FIRE STATION 15		REVISION	
THE CITY OF ALBUQUERQUE		SHEET	
ALBUQUERQUE, NEW MEXICO		3	
RICHARD P. MILNER & ASSOCIATES		OF NINE	
ALBUQUERQUE			
JOB NO. 194-5-73		DATE: 6/8/73	
DRAWN BY: WOOD		CHECKED BY: R.P.M.

CITY OF ALBUQUERQUE FIRE DEPARTMENT STATION 15 EXERCISE ROOM ADDITION

100% CONSTRUCTION DOCUMENT SUBMITTAL

A EXISTING SITE PLAN W/
PROPOSED AMENDMENTS
SECOND DSGA. PROVIDED BY APD
T = 20'-0"

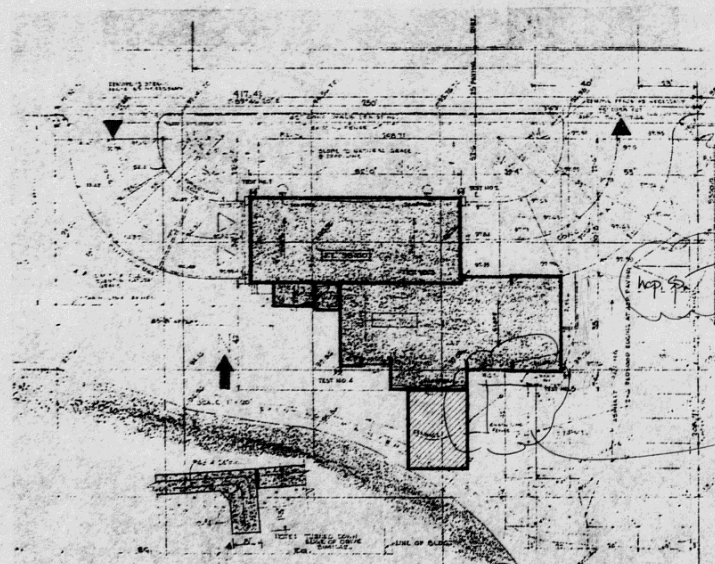
stripe path for accessibility
hwp. sp.

max. slope 1:20 typical

develop concrete path to hwp. parking.

A EXISTING SITE PLAN W/
PROPOSED AMENDMENTS
(RECORD DUGS PROVIDED BY AFD) 1" = 20'-0"

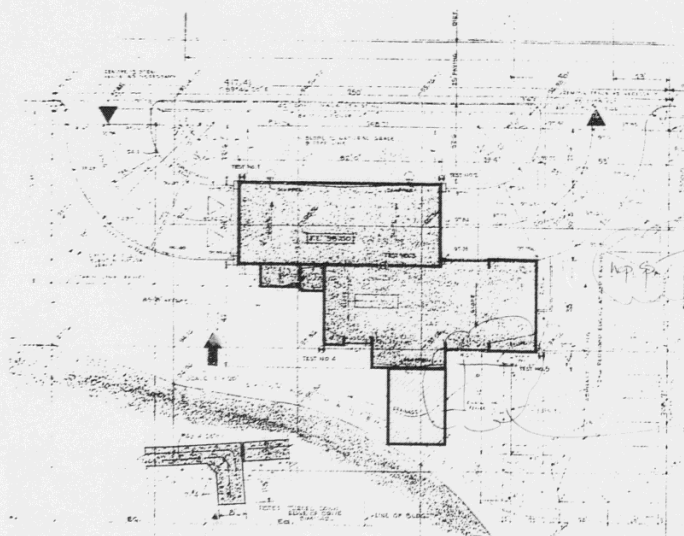
stripe path for accessibility

max. slope 1:20 typical

develop concrete path to hcp parking.
